Pentland Floating Offshore Wind Farm

Section 36C Consent and Marine Licence Variation Application Report

Document No.	GBPNTD-PGM-PEN-RP-00003
Project:	Pentland Floating Offshore Wind Farm
Originator Company	HWL
Revision	01
Author	HWL
Date	11.10.2023

Figure S32C-1a
Viewpoint 1: Beinn Ratha Wireline

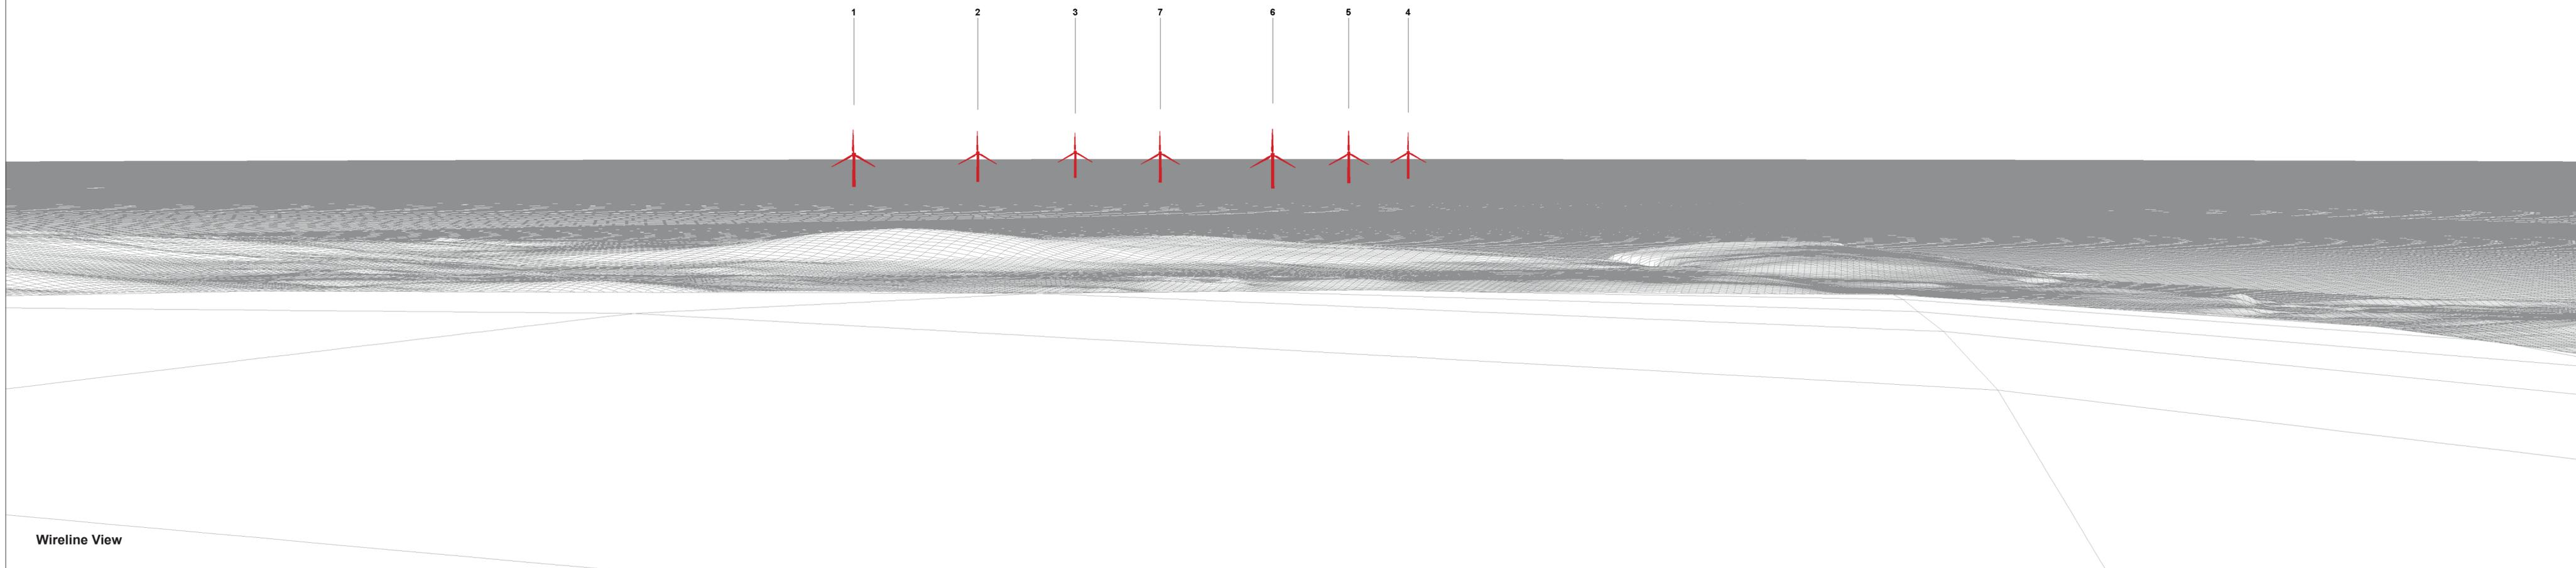
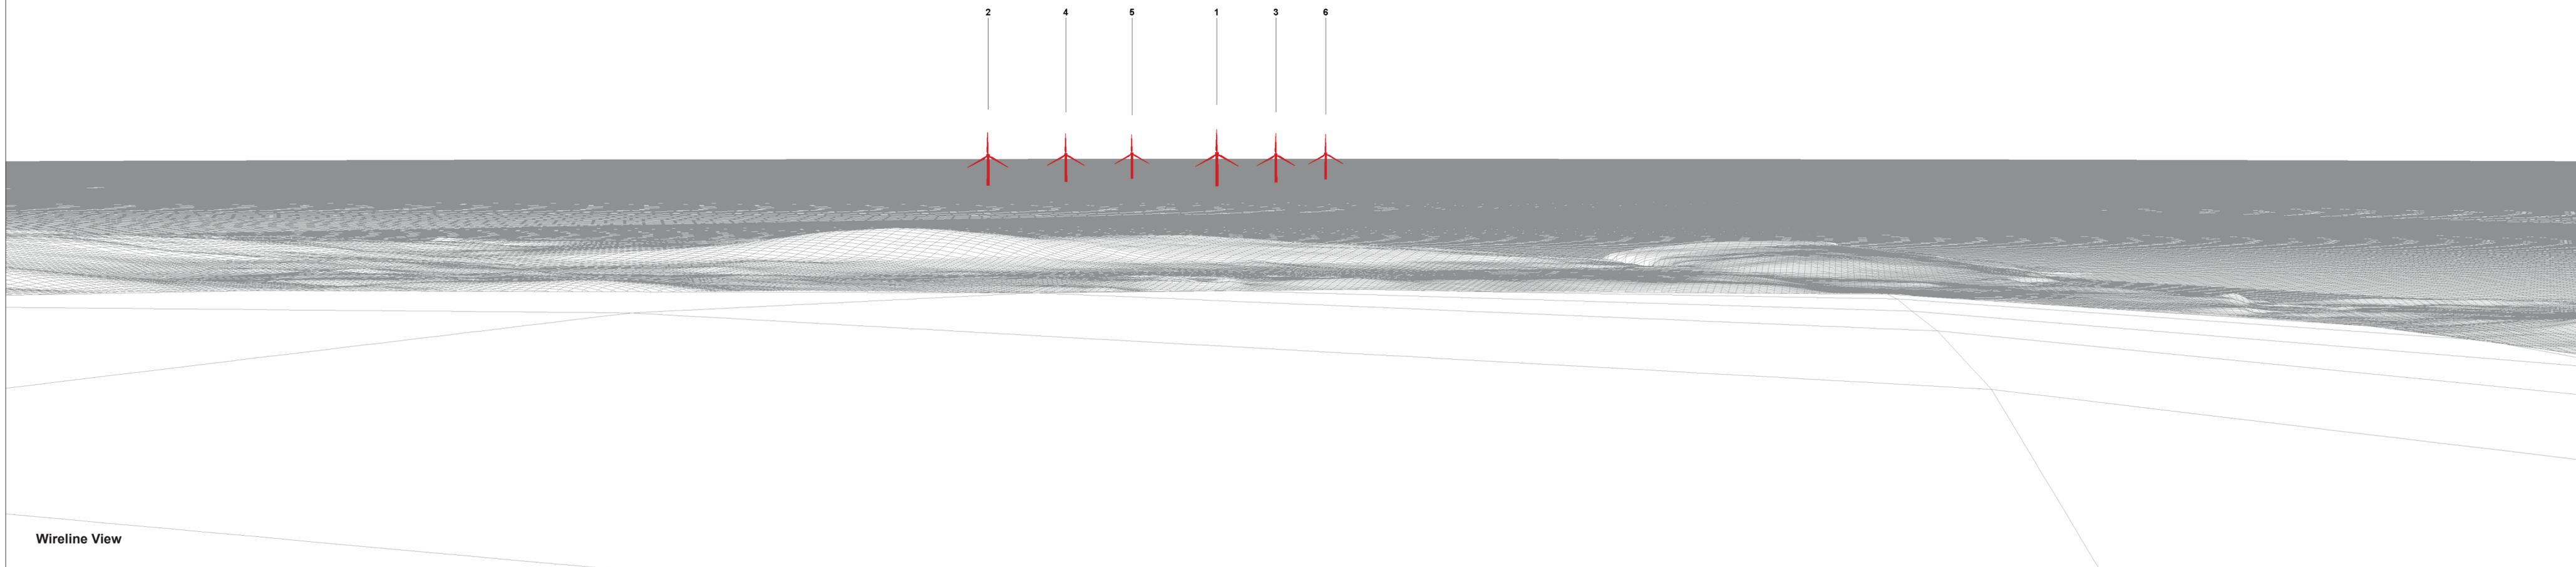
Viewpoint	Consented Parameters	Refined Parameters
1 Beinn Ratha	Sensitivity - medium-high Magnitude of change (MoC) – medium-high Significant at a major / moderate level	Reduction in horizontal extent readily apparent. Although there would be a slight reduction in MoC, overall assessment would remain unaltered owing to incremental nature of reductions and overall effect of introducing WTGs into undeveloped seascape. WTG1 (rotor diameter 220 m) appears slightly larger than the five larger WTGs (rotor diameter 250 m) owing to the location of WTG1 closest to shore and the limited difference in blade tip height of 30 m.
2 Strathy Point Car Park	Sensitivity - medium-high Magnitude of change – medium-high Significant at a major / moderate level	Reduction in horizontal extent readily apparent, especially with reference to Hoy in background. Although there would be a slight reduction in MoC, overall assessment would remain unaltered owing to incremental nature of reductions and overall effect of introducing WTGs into undeveloped seascape. WTG1 (rotor diameter 220 m) appears similar in size to the five larger WTGs (rotor diameter 250 m) owing to the location of WTG1 in the row of the array closest to shore and the limited difference in blade tip height of 30 m.

T1-7: 170m hub height, 300m tip height, 260m rotor

T1: 14MW turbine (145m hub height, 255m tip height 220m rotor)
T2-6: 17MW turbines (160m hub height, 285m tip height, 250m rotor)

Figure S32C-5a
Viewpoint 5: Sandside Head Wireline

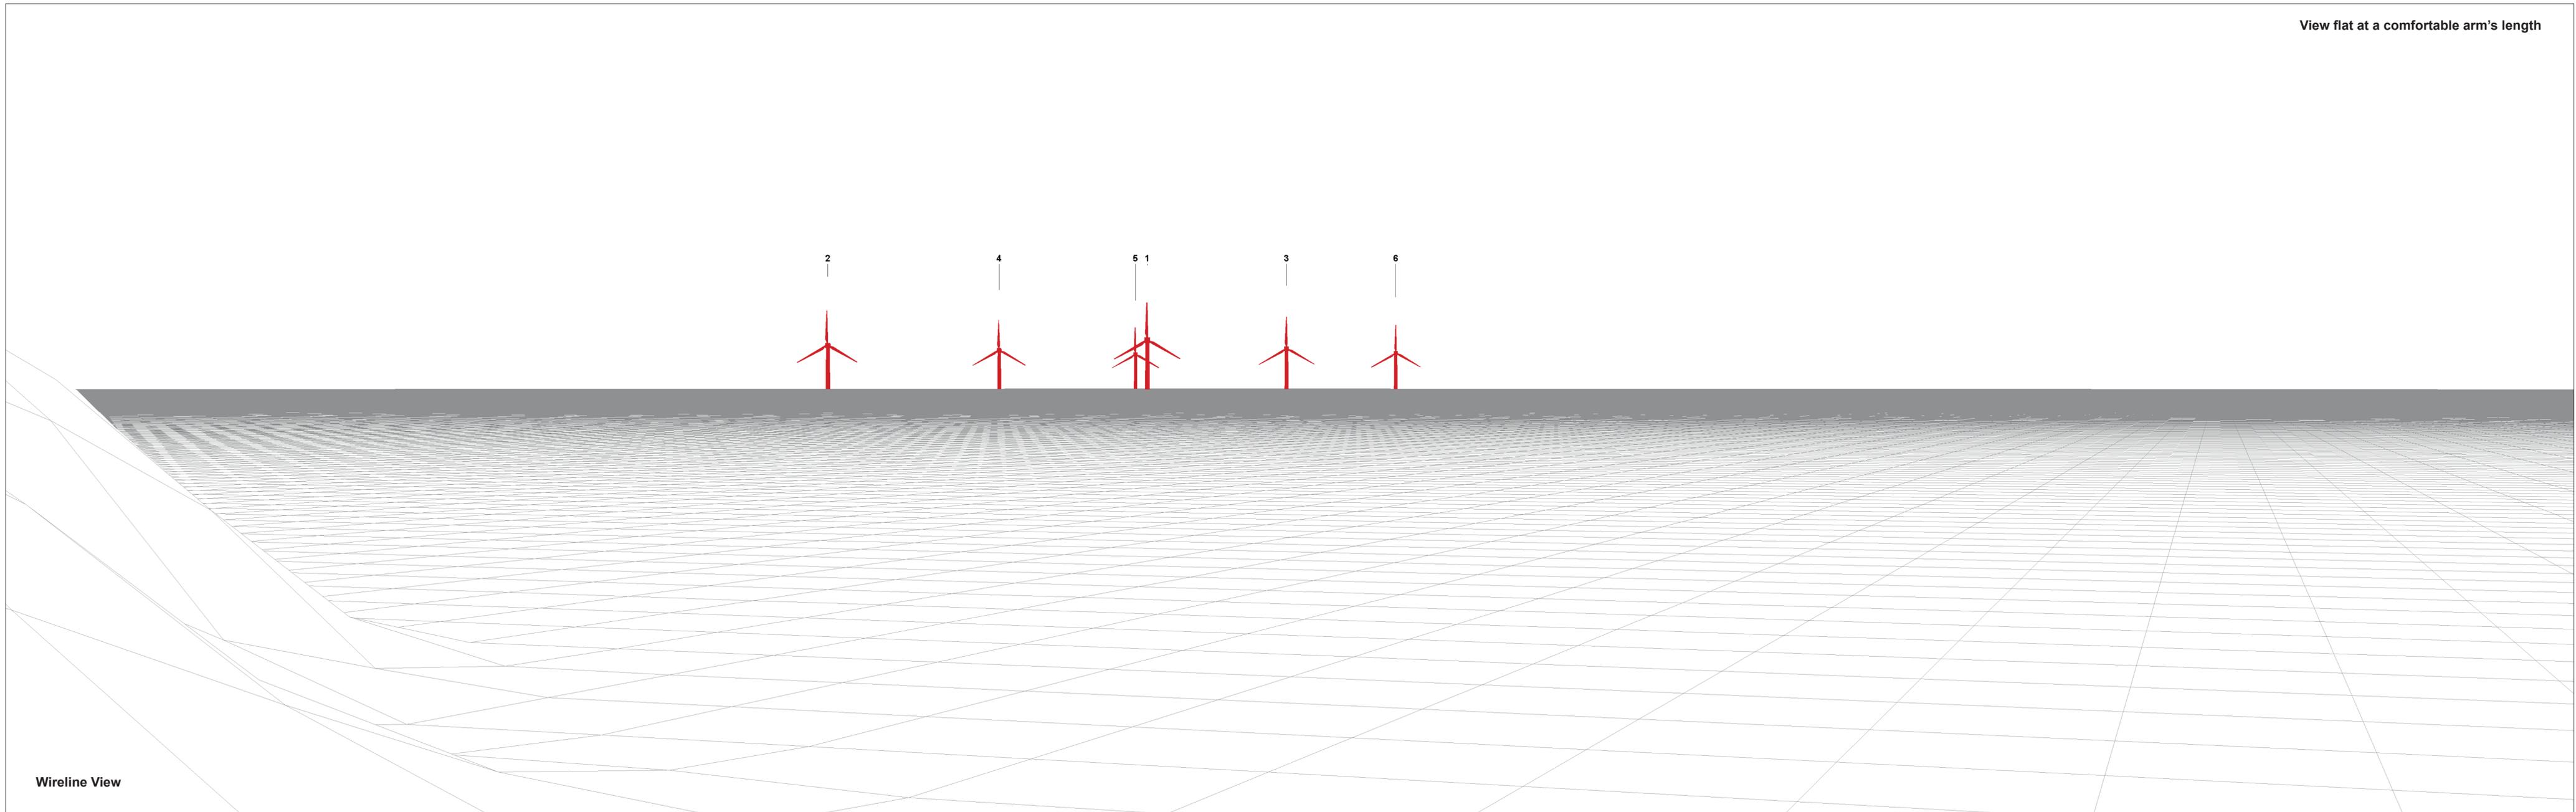
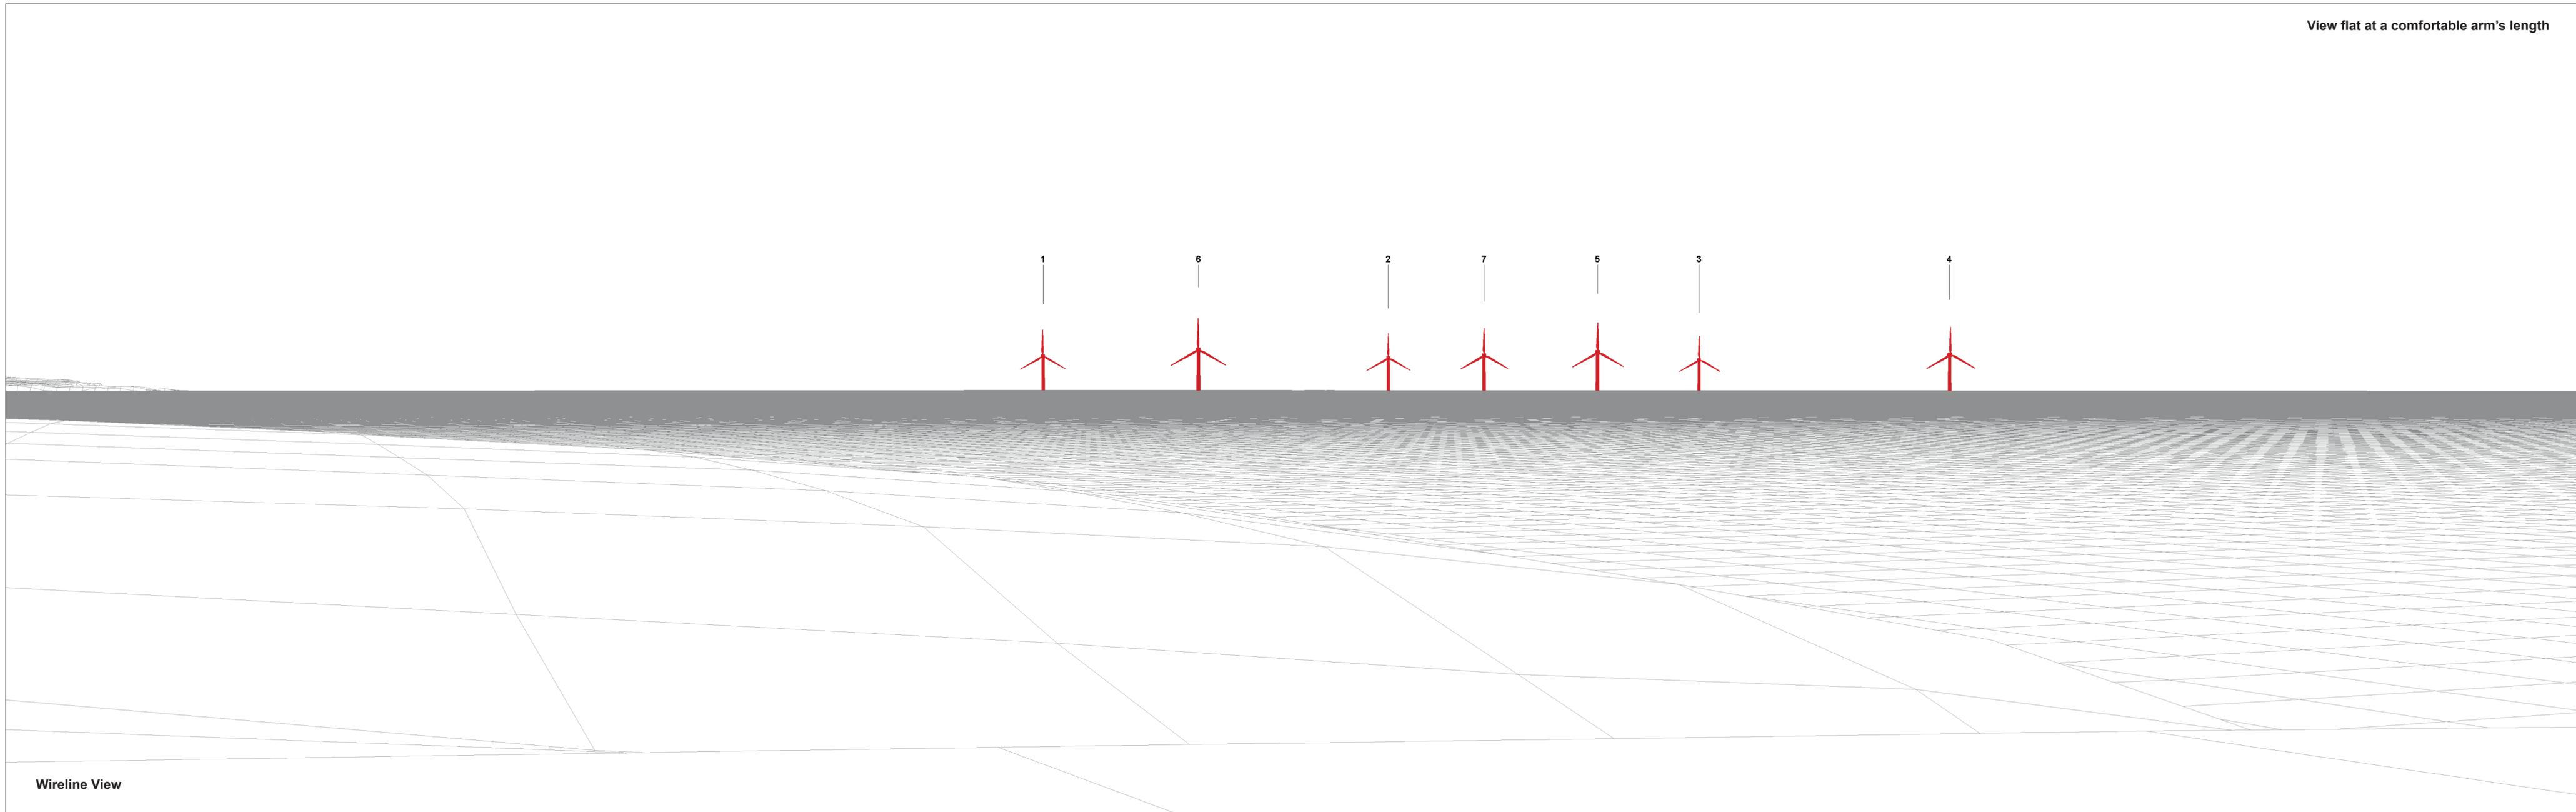
5 Sandside Headland	<p>Sensitivity - medium</p> <p>Magnitude of change – medium-high</p> <p>Significant at a moderate level</p>	<p>Reduction in horizontal extent readily apparent although overlap between central WTGs arises.</p> <p>Although there would be a slight reduction in MoC, overall assessment would remain unaltered owing to incremental nature of reductions and overall effect of introducing WTGs into undeveloped seascape.</p> <p>WTG1 (rotor diameter 220 m) appears slightly larger than the five larger WTGs (rotor diameter 250 m) owing to the limited difference in blade tip height of 30 m and the location of WTG1 closest to shore.</p>
6 St Mary's Chapel, Forss	<p>Sensitivity - medium-high</p> <p>Magnitude of change – medium-low</p> <p>Not significant at a moderate level</p>	<p>Reduction in horizontal extent readily apparent and WTGs appear very evenly spaced.</p> <p>Although there would be a slight reduction in MoC, overall assessment would remain unaltered owing to incremental nature of reductions and moderating effect of close range operational Forss WTGs.</p> <p>WTG1 (rotor diameter 220 m) appears similar in size to the five larger WTGs (rotor diameter 250 m) owing to the limited difference in blade tip height of 30 m and the location of WTG1 in the row of the array closest to shore.</p>
